Department of Energy

96-DOE-05505

This is in response to your letter dated May 3, 1996. In that letter you expressed EPA's concern regarding whether the area of Operable Unit (OU) 1 that is to be excavated as part of the preferred remedial alternative in the Proposed Plan has been adequately characterized to accurately determine the area of excavation. DOE believes that the area has been adequately characterized and does not believe that downgradient subsurface soils contain a contamination source that is contributing to groundwater contamination downgradient of IHSS 119.1.

**CARBON TET
WELL 0487**

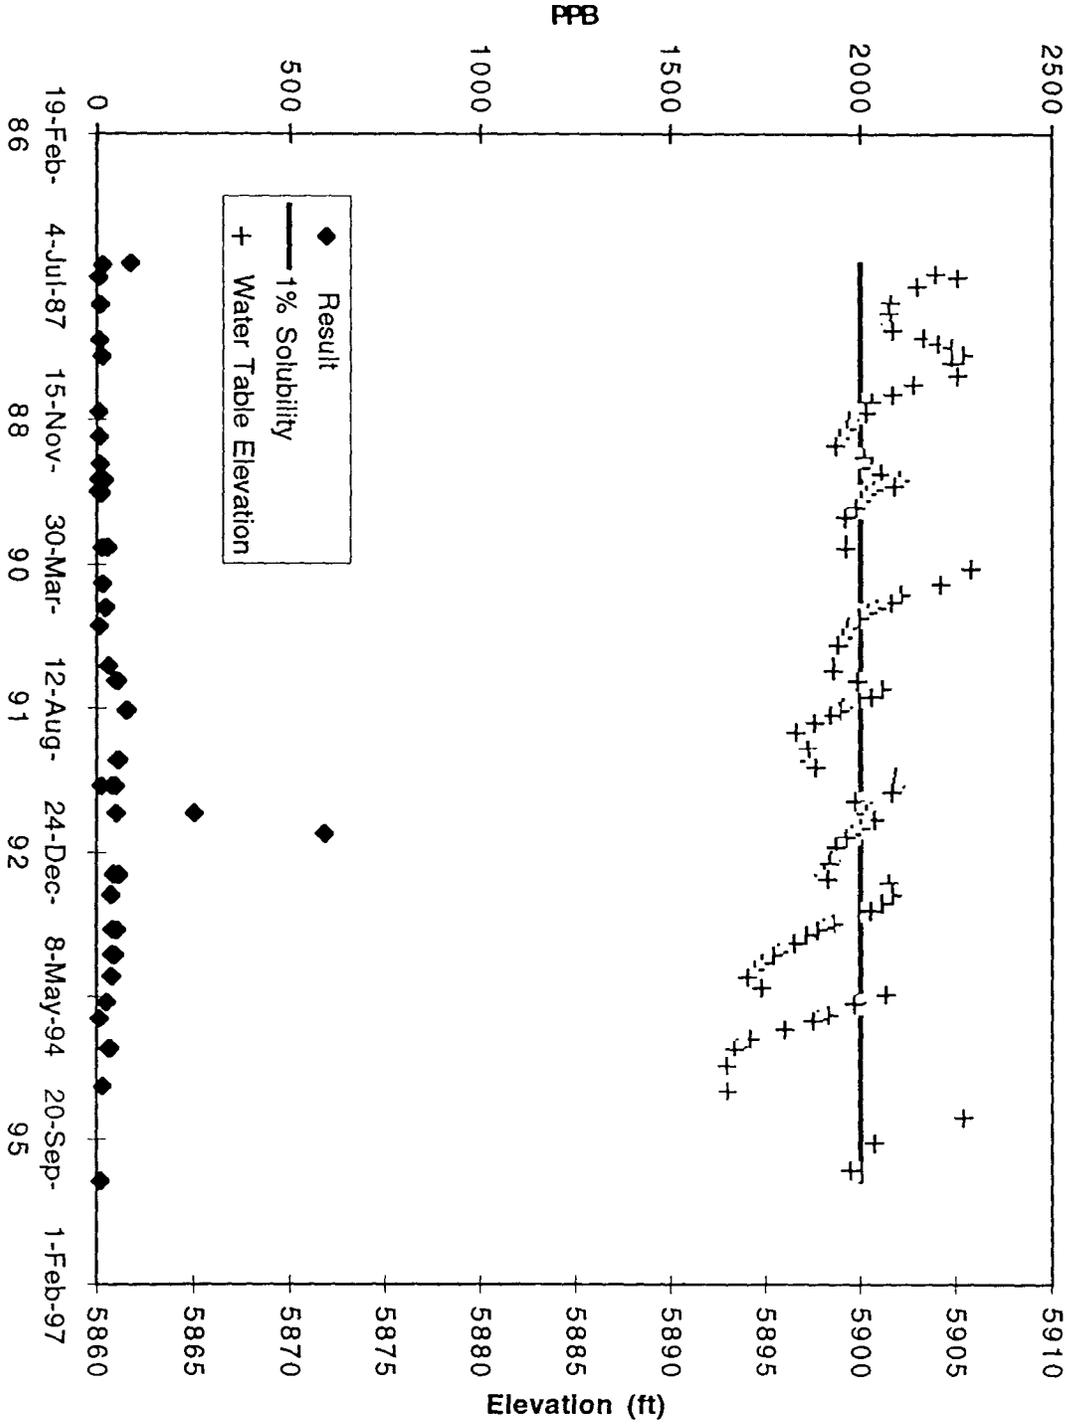
In addition, enclosed in this letter are graphs that represent observed concentrations of contaminants of concern in well 0487 in relationship to the water table elevation and the 1% solubility limit. These data support the conclusion that residual or free phase DNAPL is not in the vicinity of well 0487.
